FPL

L-2004-193
10 CFR 50.90

RE: St. Lucie Unit 2
Docket No. 50-389
Proposed License Amendment
Request for Additional Information Response
WCAP-9272 Reload Methodology and
Implementing 30% Steam Generator Tube Plugging Limit

FIGURE 2

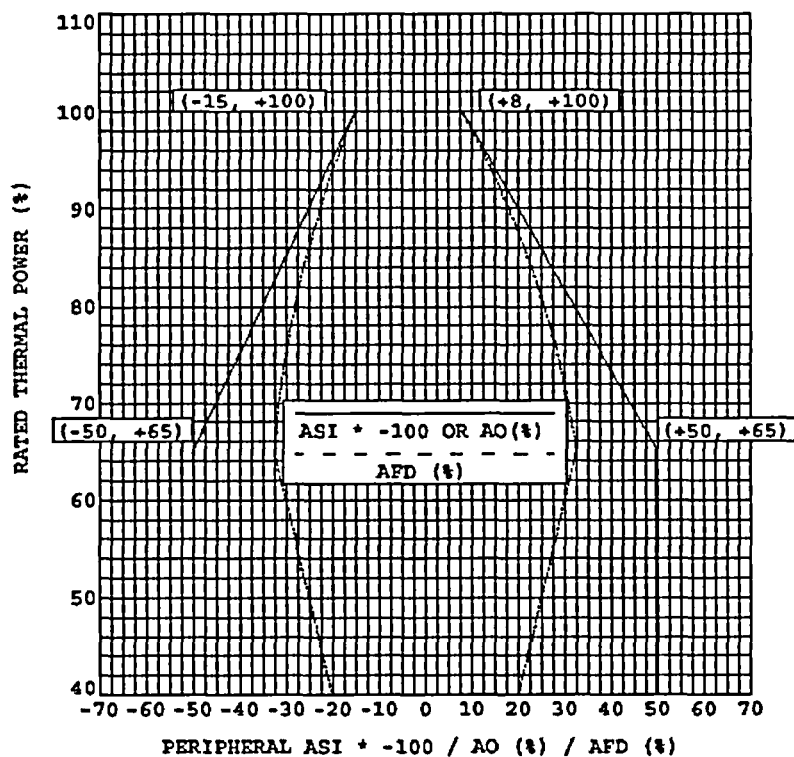
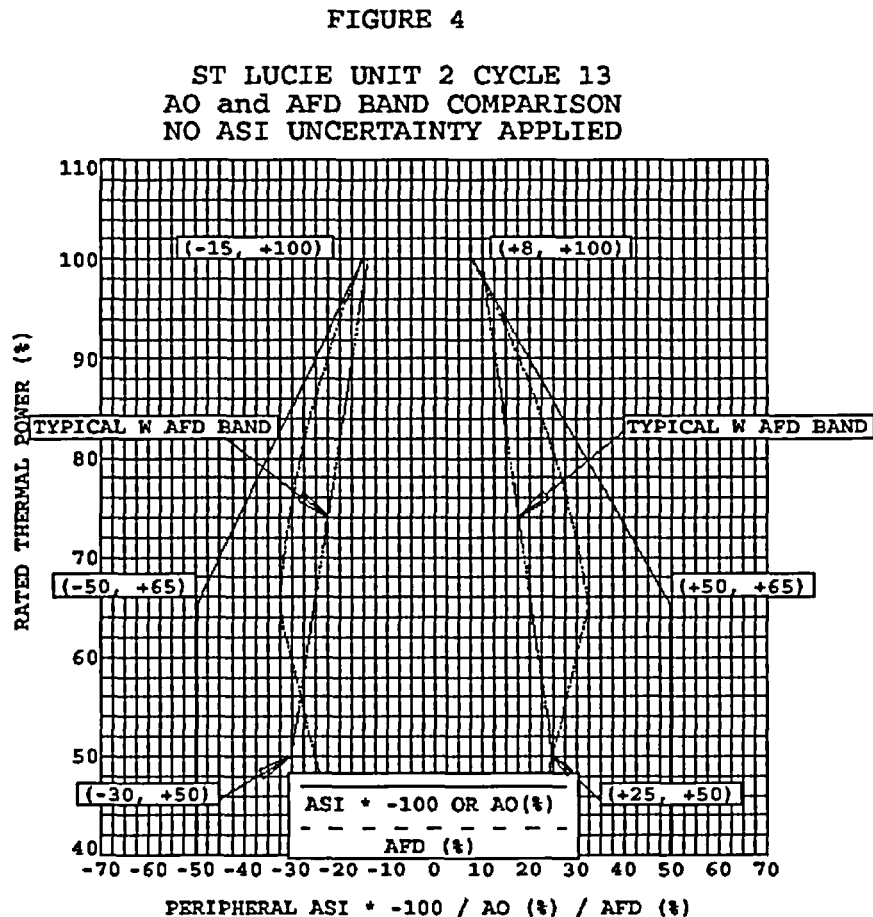
The first paragraph on page 3-3 does not adequately discuss the six bullets provided in Section 3.6. Please provide detail quantitative and qualitative technical justification for each one of these bullets, in particular, the subject of non-linear relationship for axial flux and the elimination of the positive MTC. What is a part power multiplier?

In addition to each of the six bullets, the following information is provided to supplement the discussion on the non-linear relationship for axial flux. The definition of the band used to control the axial power distribution at St Lucie Unit 2 is different from that used in standard Westinghouse plants. Although the shape of the curve (which resembles a "doghouse") is similar, the two quantities represented are not the same. At St. Lucie Unit 2, the band defines Axial Shape Index (ASI) as a function of core average power; in standard Westinghouse plants, the band defines Axial Flux Difference (AFD) as a function of core average power.

The following figure shows an example of a St. Lucie Unit 2 band in terms of both ASI and AFD. As can be seen, the ASI band has linear segments whereas the AFD band is non-linear.
